Limited Validity - Warning Message "Spoiler fault": Replacing spoiler (60/17)

Vehicle Type: **Panamera Turbo (971)**

Subject: **Rear spoiler**

Spoiler with clamping screw

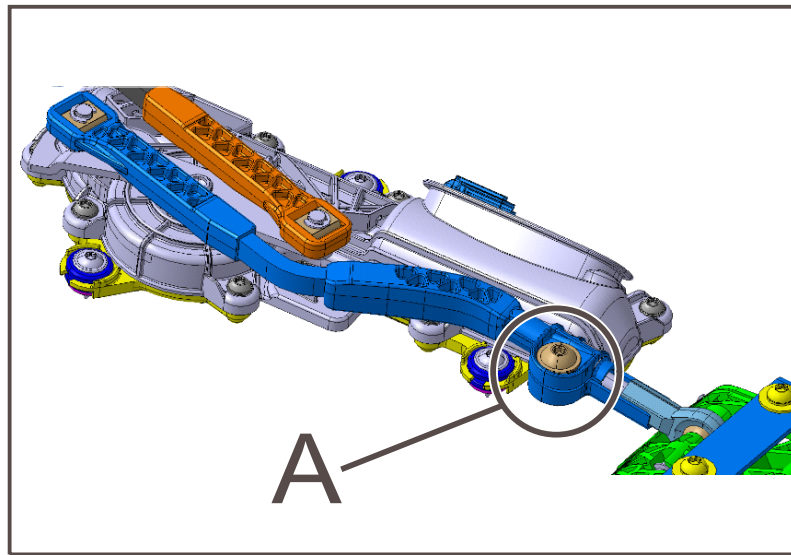
The new type differs from the previous type in that it has a clamping screw (see ⇒ *Spoiler with clamping screw*-**item A**-).

⇒ If there is **still a clamping nut** on the connecting link on the existing rear spoiler, **the rear spoiler must be replaced**.

⇒ **The faulty clamping sleeve/a loose clamping nut must not be replaced or repaired.**

Parts Info: 971.827.678.AYG.2X ⇒ Rear spoiler
